Peer Review of Hudson River PCBs Reassessment RI/FS Phase 2 Reports

**Data Evaluation and Interpretation Report
Low Resolution Sediment Coring Report**

Premeeting Comments

**Albany, New York
March 16-18, 1999**

Fig. D1-1. Water Column PCB Concentrations for Summer-Low Flow Conditions (Transect 6)

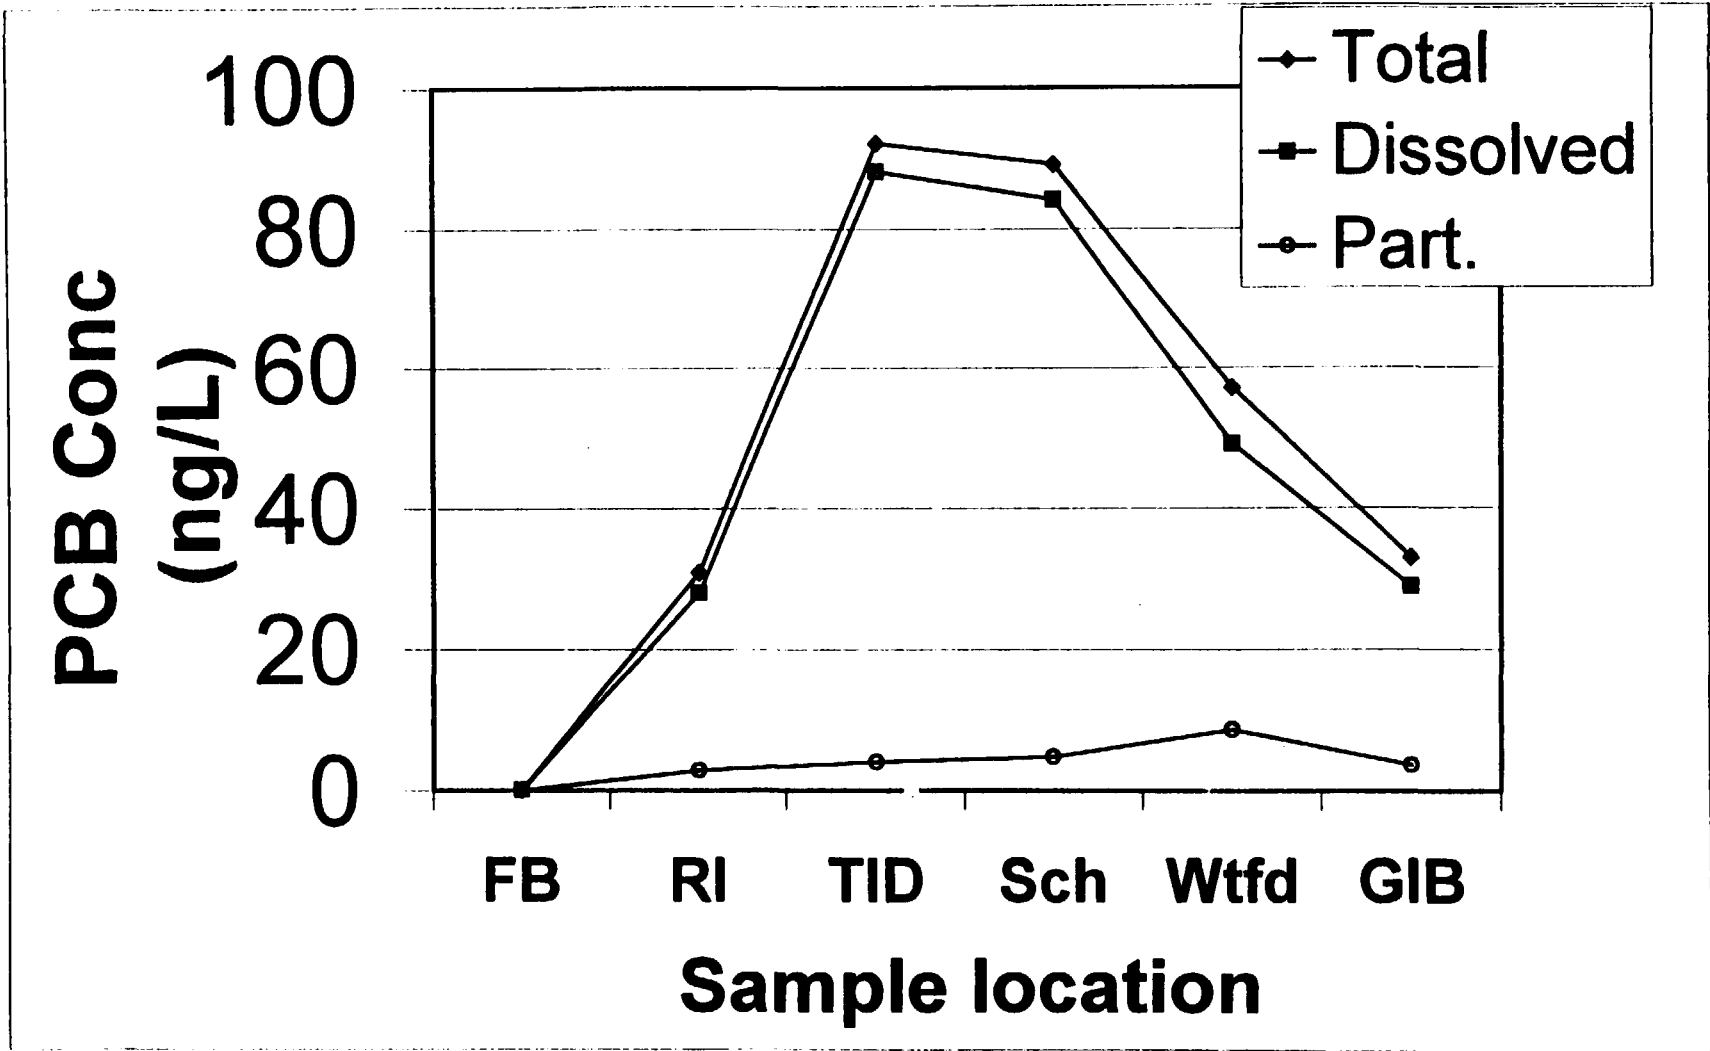
The origin of the PCBs within the TI Pool sediment inventory and what is meant by "historically-deposited" is less clear. From the LRC study, it is clear that "shallow" layers (<10 in depth) still contain a large PCB inventory at many TI Pool locations. Whether the water column PCBs originated from deeper, historically contaminated layers or recently deposited sediments cannot easily be determined. My own analysis of the LRC data indicates that sediment PCBs are split roughly 50:50 between shallow (0-8cm) and deep (>8 cm) layers (see also my comment on LRC Question 6). Each layer is dechlorinated, deeper layers probably being more so.

The only alternative explanation for these profiles is selective leaching of mono- and dichloro homologs from relatively immobile free product (oil droplets) upstream of the TI Pool. This would also require enhanced or accelerated "dispersion" of these homologs away from the source and a corresponding attenuation of trichloro- and higher homologs ("Tri+") in sediments upstream of the TI Pool. This scenario, however, would have been observed as a gradual shift in the homolog profile between the upstream Allen Mills source and the head of the TI Pool (Rogers Island). Since the sediments and water column samples collected at Rogers Island had a very different homolog pattern than that within the TI Pool (Figs. C-2 through C-4, and 3-38, 3-40, 3-43 and 3-47), this scenario is not a very likely one.

Fig. D2-1. Estimated Phase 2 $\log K$'s show increasing trend with $\log K_{ow}$ (Hawker and Connell 1988)

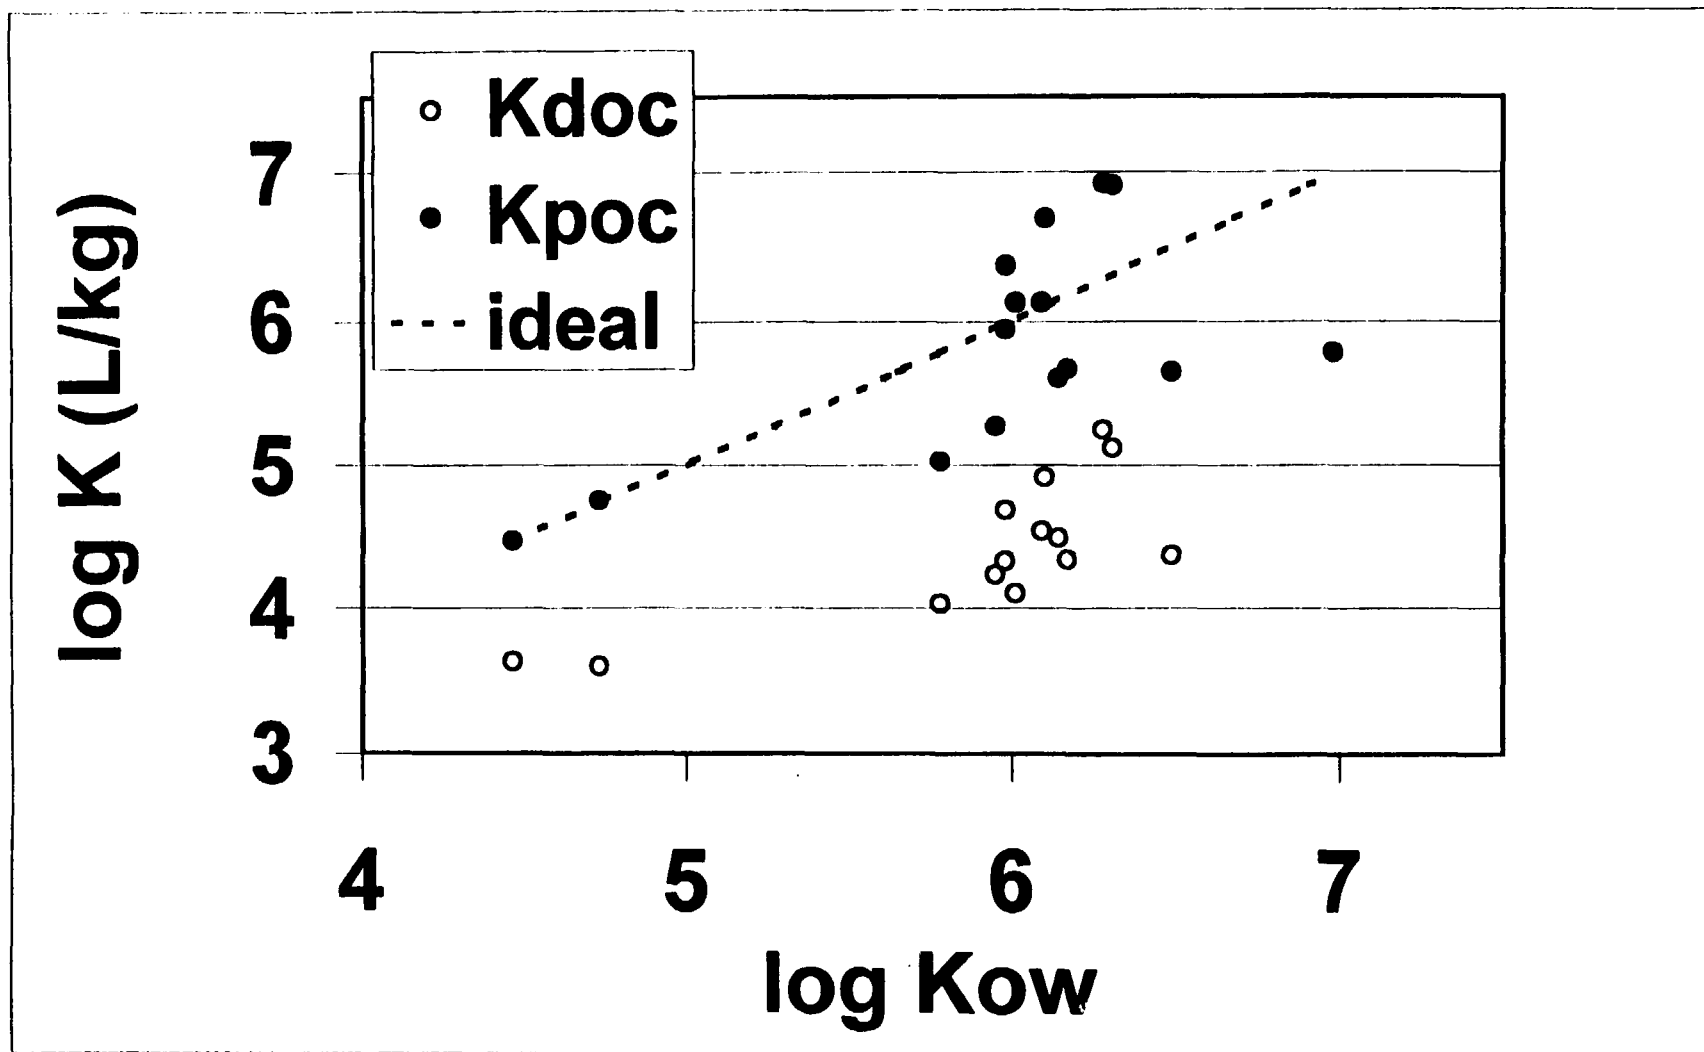
These estimates are presented for partitioning in the water column in Table 3-8 of the DEIR, and appear again as corrected values for bedded sediments (i.e. sediment and porewater distributions) in Table 2-2 of Book 3 of the DEIR Responsiveness Summary. In Table 2-2, K values are given for coeluting congener combinations with $K_{POC} > K_{DOC}$ without exception. My own analysis of the data show that log K's are positively correlated with log K_{ow} ($p < 0.01$; see Fig. D2-1 and Table D2-1 below). For New Bedford Harbor sediments, positive K_{POC} - K_{ow} associations were also noted by Burgess et al. (1996) and Brownawell and Farrington (1986). However, in Table 3-8, one curious exception is noted for BZ#8, where the estimated K_{POC} (5.19) is less than K_{DOC} (5.43). No explanation is given for this unique trend reversal, other than the fact that footnote "c" in Table 3-8 indicates some sort of blank problem. It is not clear if the congener specific results in Table 3-8 will be used in the future. If they are, I suggest that values for BZ#8 be revisited. If the data for BZ#8 turn out to be of questionable quality, interpolation or regressions based on aqueous solubility or K_{ow} , should be considered to estimate K values for this congener. For any future predictions of K, a quick check of the trend with increasing chlorines (or log K_{ow}) can be performed as a quick sanity check of the model.

I would thus recommend simplifying the partitioning model back to a 2-phase model instead of a 3-phase model. In the 2-phase model, DOC would be included as a more-or-less constant influence in the apparent or operationally defined dissolved phase.

Fig. D3-1. Model of PCB loading and downstream transport.

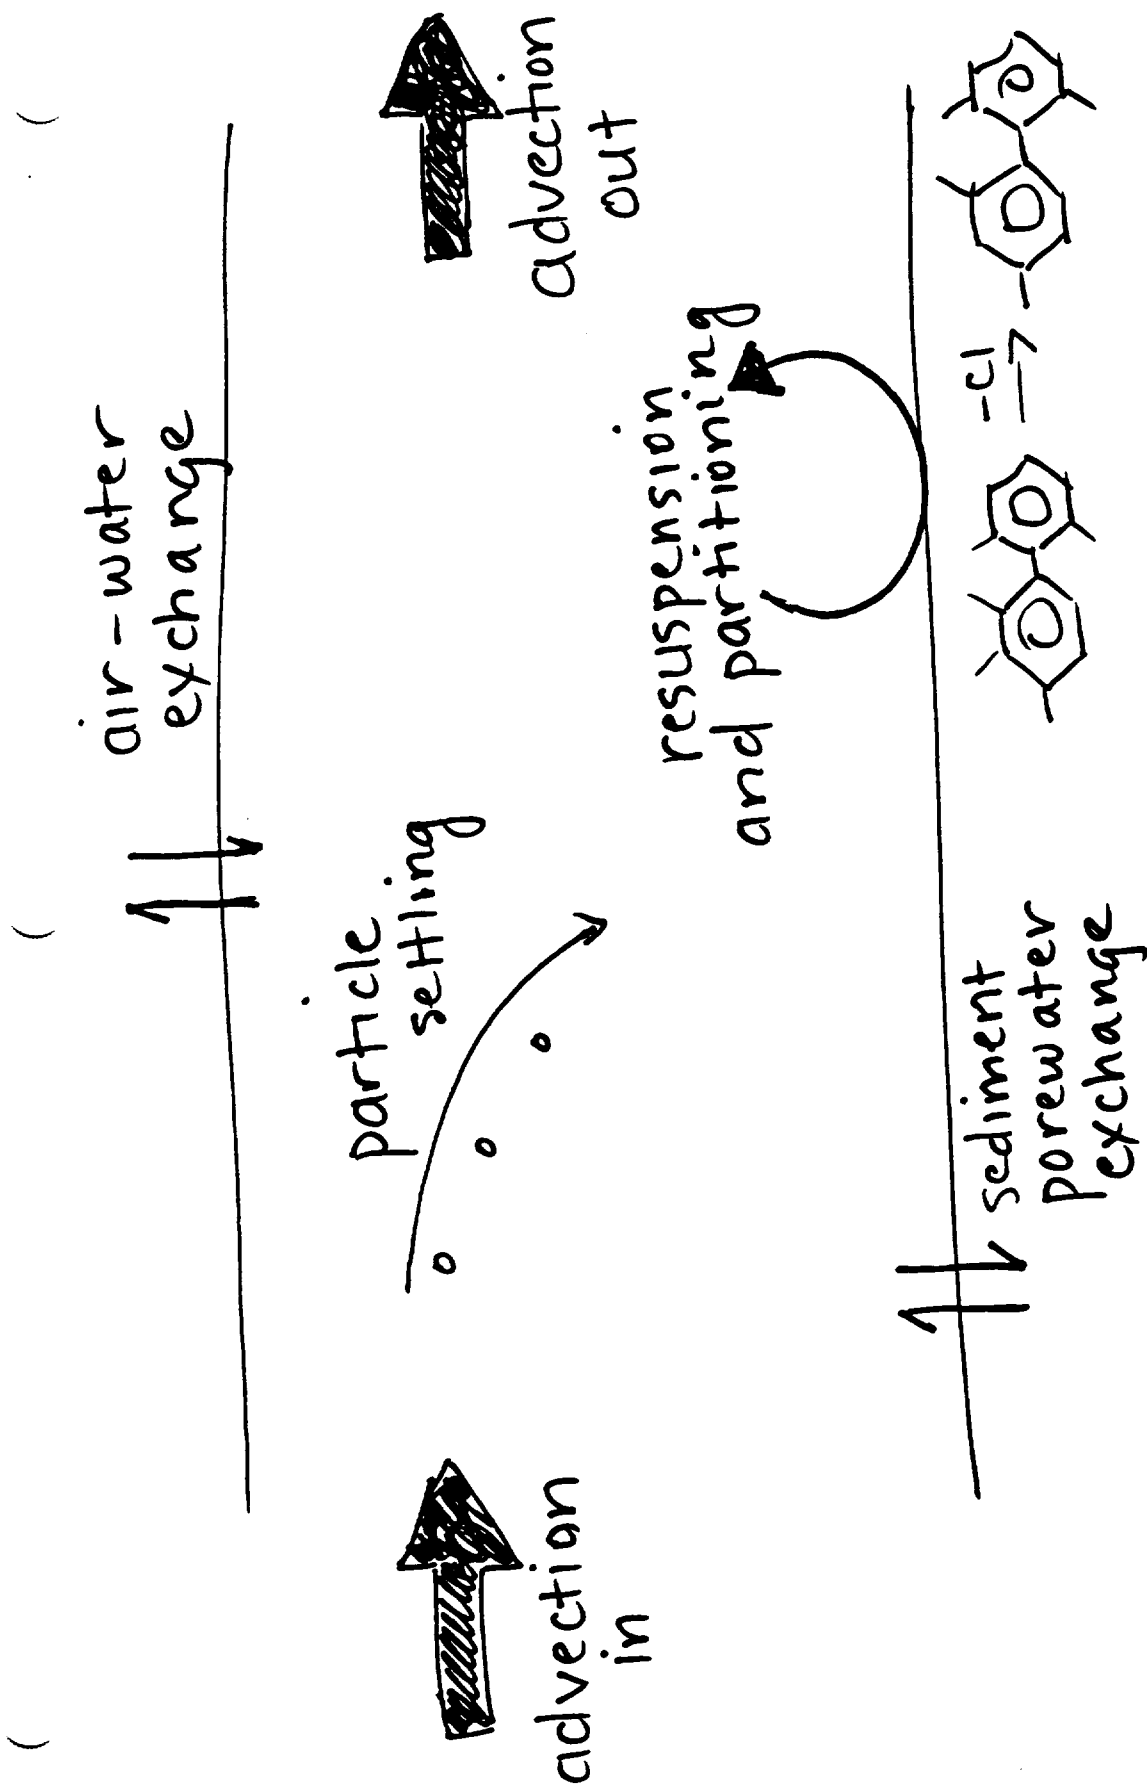
More limnological data (e.g. residence times; chlorophyll *a*, temperature gradients/stratification during summer low flow conditions) would likely improve our understanding of the processes at work in the TI Pool. For example, this stretch would seemingly act much more like a lake than upstream and/or narrower stretches of the Upper Hudson. As such, the processes acting on PCBs that are enhanced under lake-like conditions will be most important. The larger surface area to volume, increased residence time and quiescent flow regimes would likely result not only in greater fluxes of PCBs out of sediments and into the water column, but also into the air! Mass transport between phases is dependent both on the magnitude of the concentration gradient and surface area. The increased dissolved phase PCBs thus provide a larger driving force for transport out of the water column into the air. This flux would increase under summer, low-flow conditions when both air and water temperatures are at their annual maximum.

Fig. D3-2. Aqueous solubilities and Henry's Law constants (from Dunnivant et al. 1992)

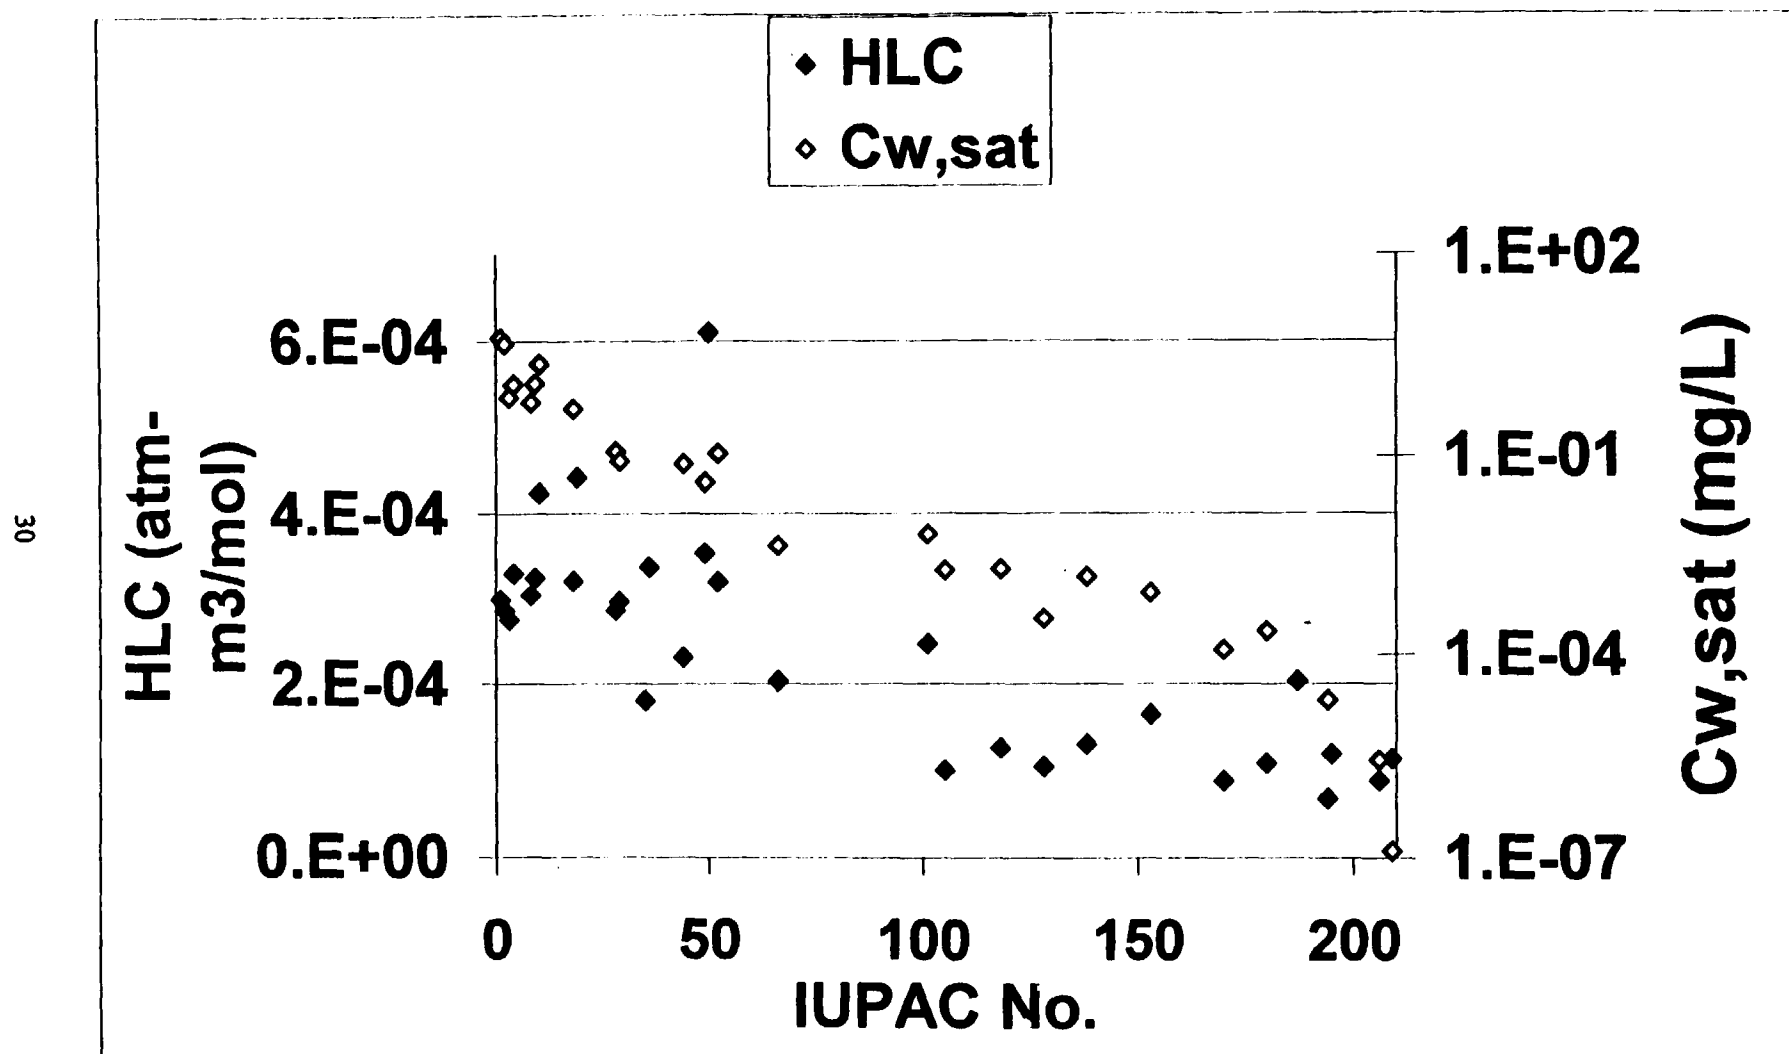
Because of their physicochemical properties including aqueous solubility and Henry's Law constants (see Fig. D3-2 below), mono- and diCBs will preferentially partition into the dissolved phase and into the atmosphere relative to heavier homologs. If air above the Hudson River is undersaturated, a constant flux of PCBs to the atmosphere can act to continually pull PCBs from the source (sediment) into the water column so that a concentration gradient is maintained.
